# Dunmore Sand and Soil Quarry

## Traffic Management Plan

Prepared for Dunmore Sand and Soil Pty Ltd  
July 2021

**Table 1.3 Combined SCC and KCC comments and EMM responses**

DRAWING TITLE:  
**SIGNS AND LINEMARKING PLAN**

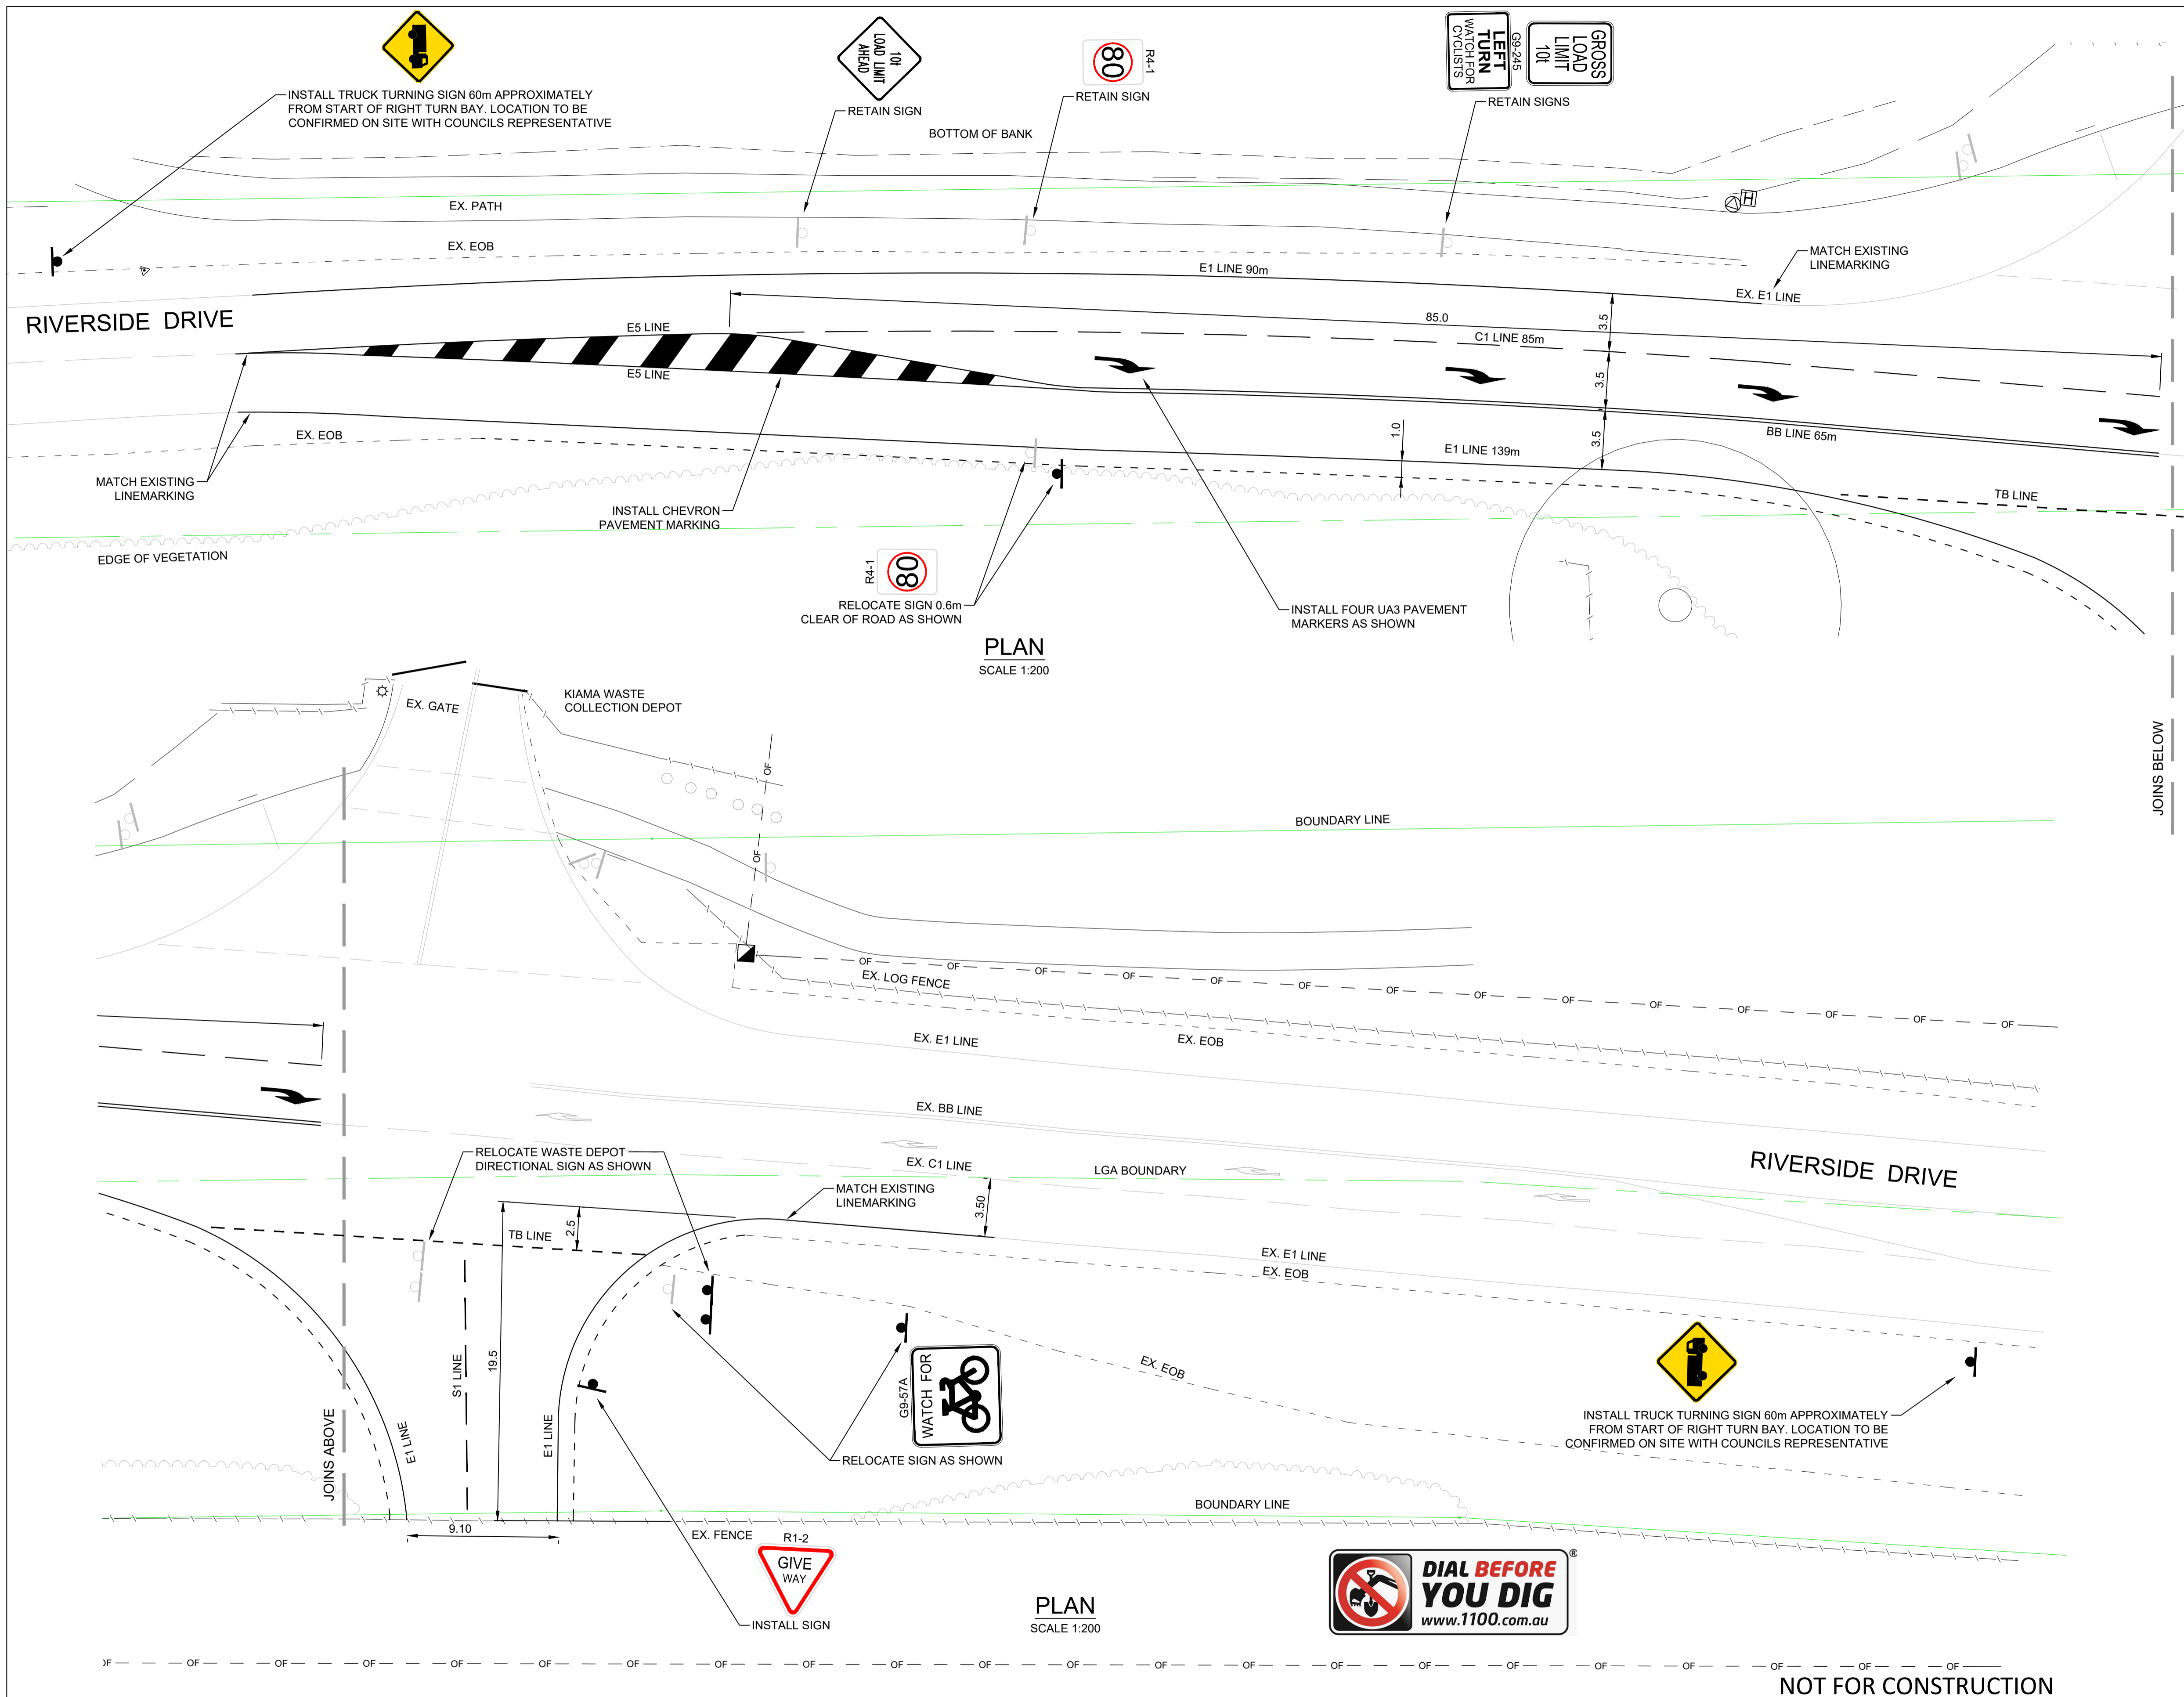
Item no	Comments	Responses
1.	The CHR intersection shown on dwg EMM-C03 appears to have the end of the new right turn lane to the site too close to the existing right turn lane to the waste depot. There is concern there will be vehicle conflict should two trucks be turning simultaneously into each site. Dwg C04 should show the equivalent right turn manoeuvring template into the waste depot.	The updated drawing EMM-C08 (Attachment A) includes two simultaneous swept paths, the right turn movement into the site and the right turn movement into the waste depot.  The swept paths have been redrawn while keeping the vehicle paths within the right turn lane up to a maximum extent before crossing the BB line. The turning point of the swept path is controlled by the trucks turning radii to enter both the facilities.  There is no vehicle conflict between the two simultaneous movements as shown in the swept path.

3.	On Dwg C03 there are no dimensions provided that show a truck entering the site will be wholly contained off the Riverside Dr travel lane, if a gate is installed at the existing property fence line.	The updated TMP includes control provisions (section 5.8) that will ensure no truck approaches the Stage 5A site, without first receiving confirmation at the weighbridge, after being weighed that the gate is open to allow trucks entering the site to enter the site without interruption. Thereby there is no need for trucks to be waiting in the verge of riverside drive, as trucks will wholly enter the site.

DRAWING TITLE:  
**SWEPT PATHS**  
 SWEPT PATHS B-DOUBLE 25m LONG

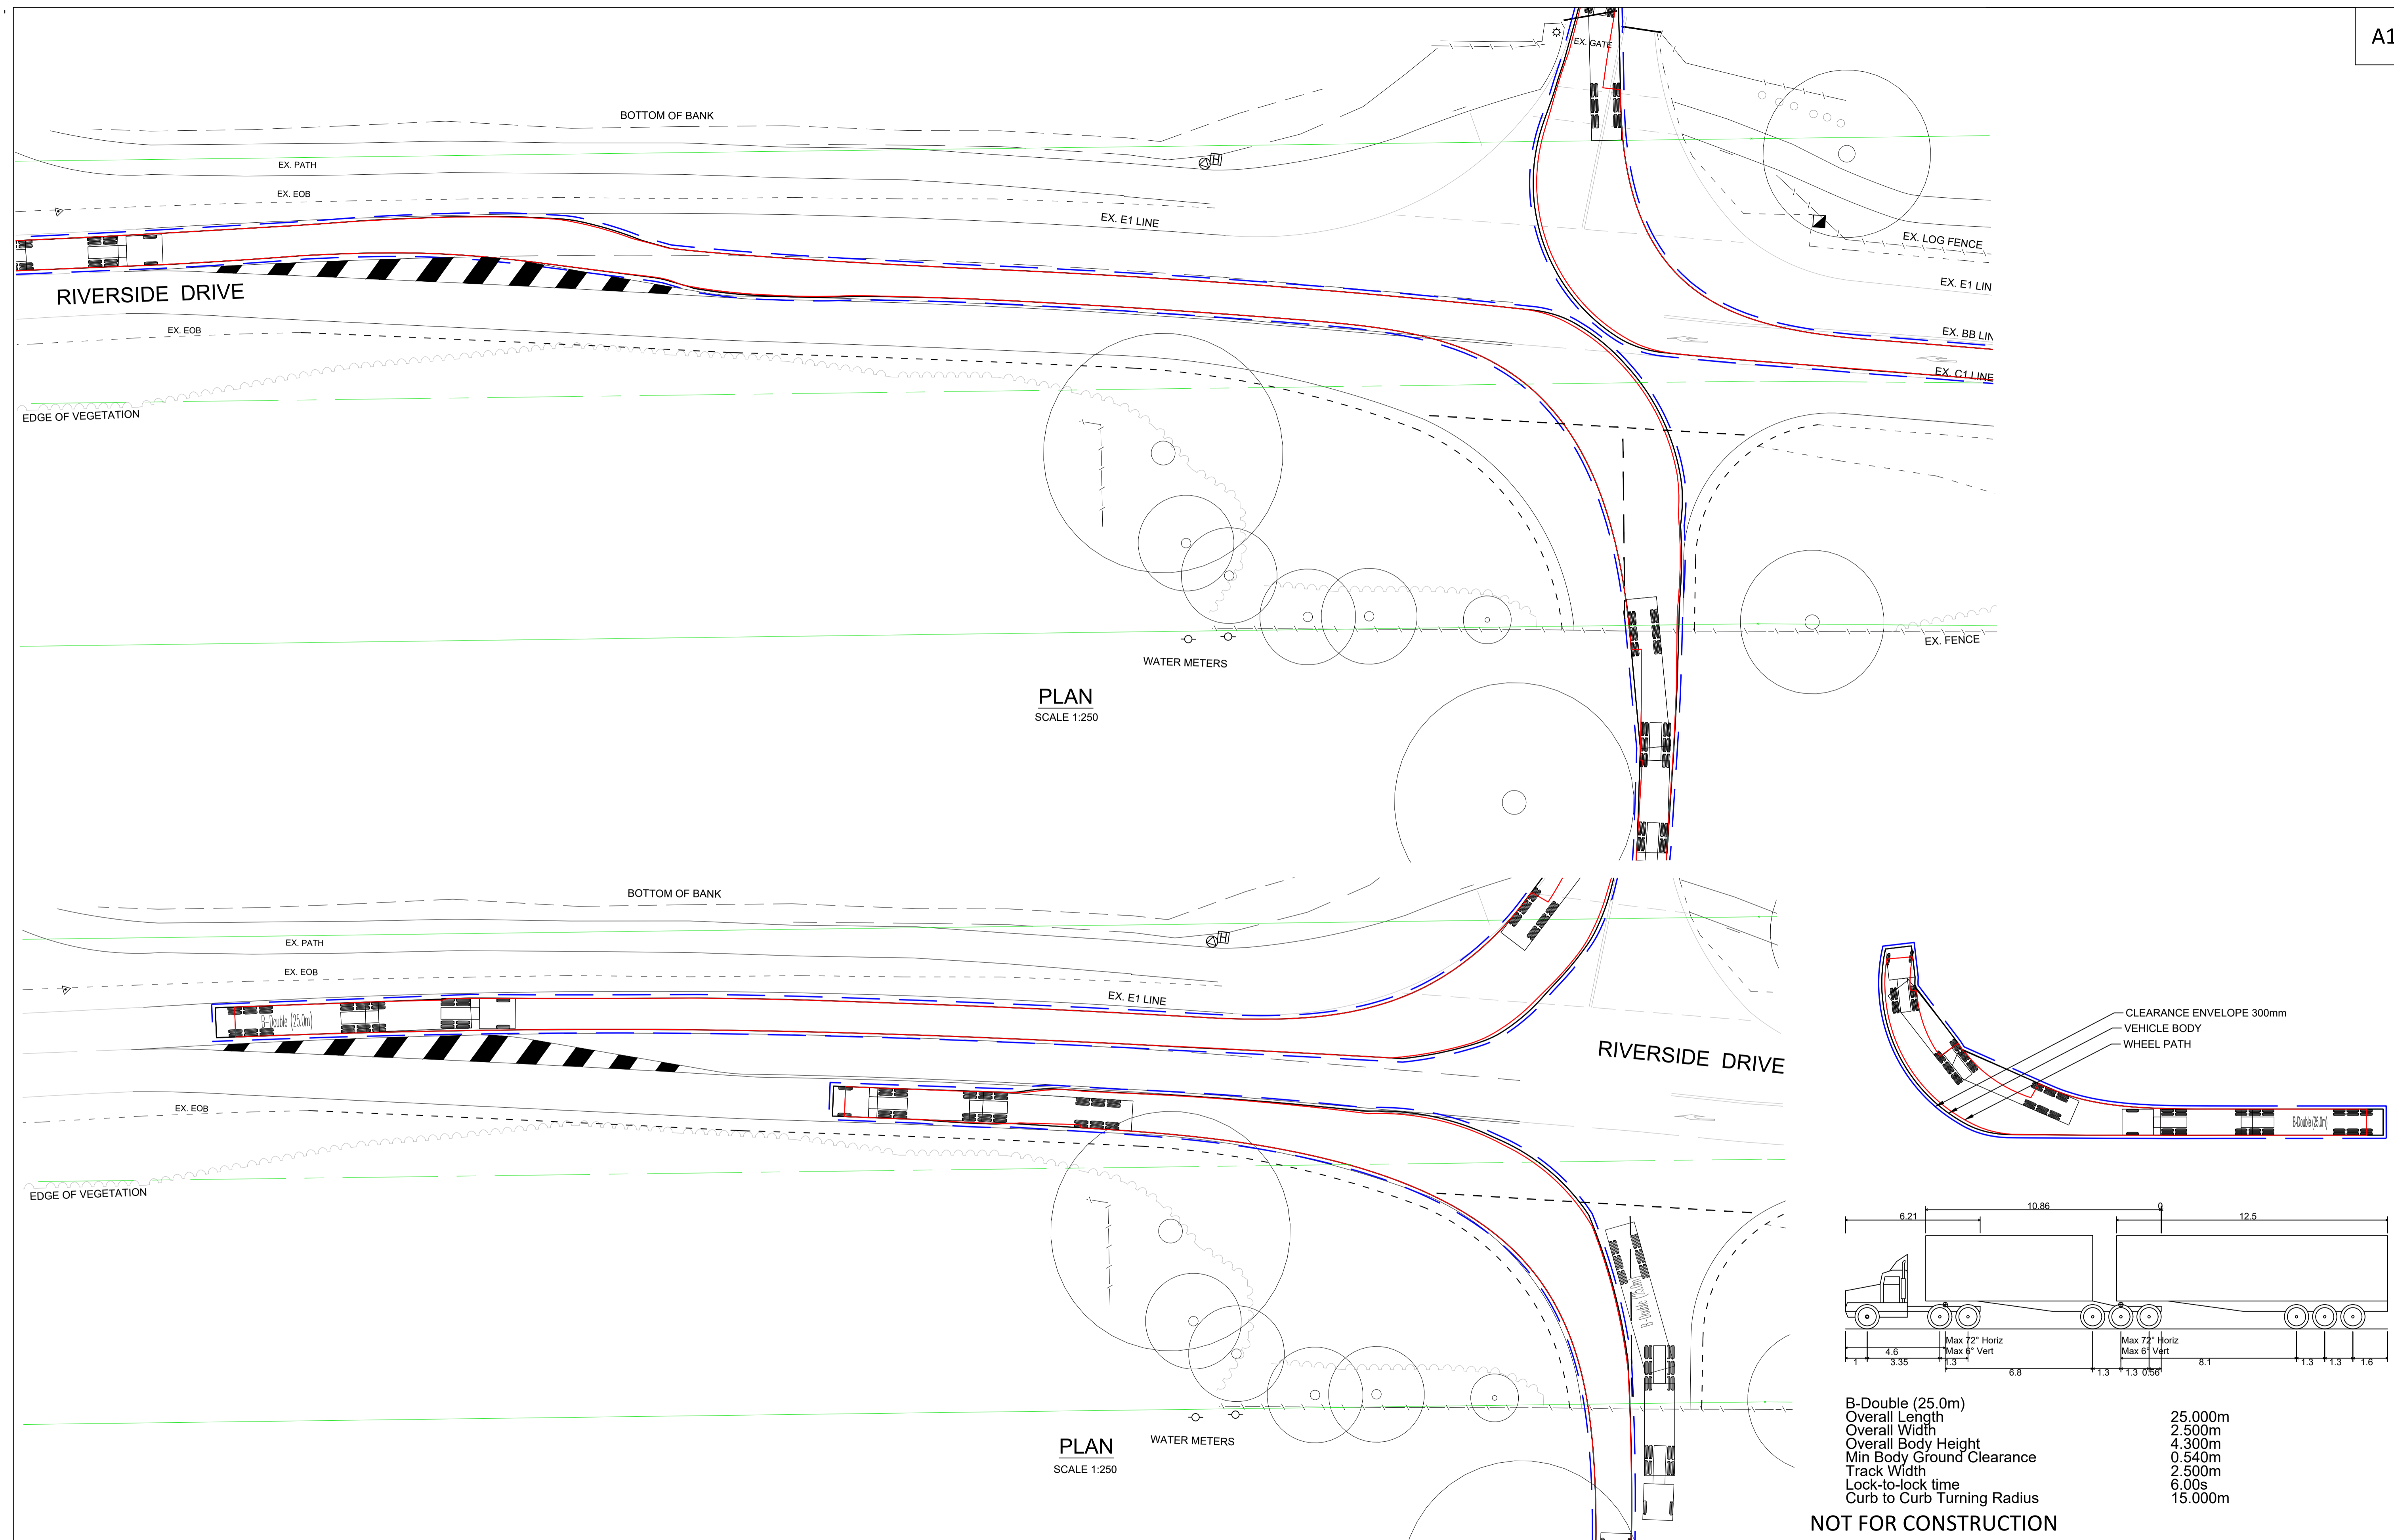
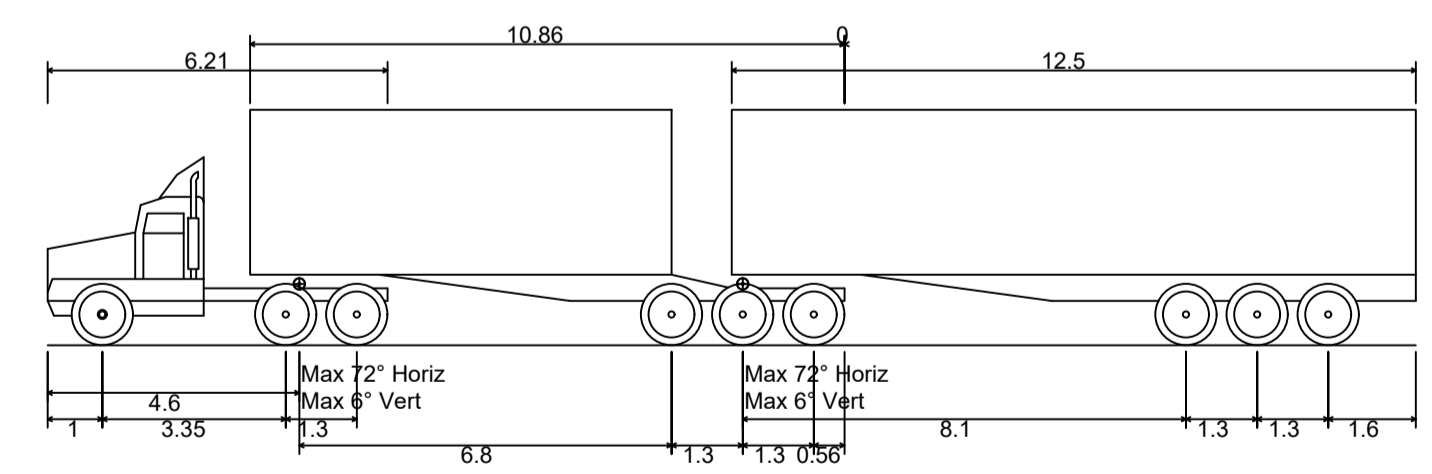
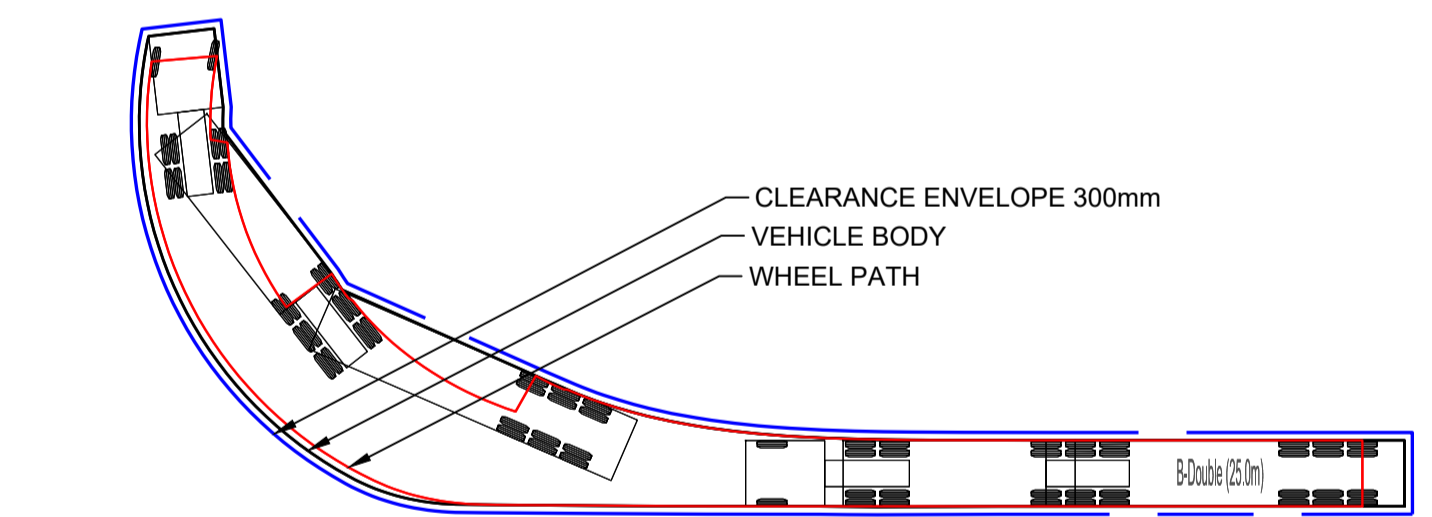
2.	Dwg C04 shows the truck turning template entering the site, tracking over a substantial portion of the proposed BB line shown on Dwg C03. If there are any vehicles exiting the site & waiting to turn right onto Riverside Drive, they will be impacted by this manoeuvre.	The updated drawing EMM-C07 (Attachment A) shows the previous BB line has been replaced by S1 line. The new S1 line has been offset from the centre and drawn inclined at an angle. Additionally, the TB line has been set back by 2.5 metres. The above changes will reduce the impact the right turning truck will have on the exiting vehicles from the site.

there will be vehicle conflict should two trucks be turning simultaneously into each site. Dwg C04 should show the equivalent right turn manoeuvring template into the waste depot.

2. Dwg C04 shows the truck turning template entering the site, tracking over a substantial portion of the proposed BB line shown on Dwg C03. If there are any vehicles exiting the site & waiting to turn right onto Riverside Drive, they will be impacted by this manoeuvre.
3. On Dwg C03 there are no dimensions provided that show a truck entering the site will be wholly contained off the Riverside Dr travel lane, if a gate is installed at the existing property fenceline.
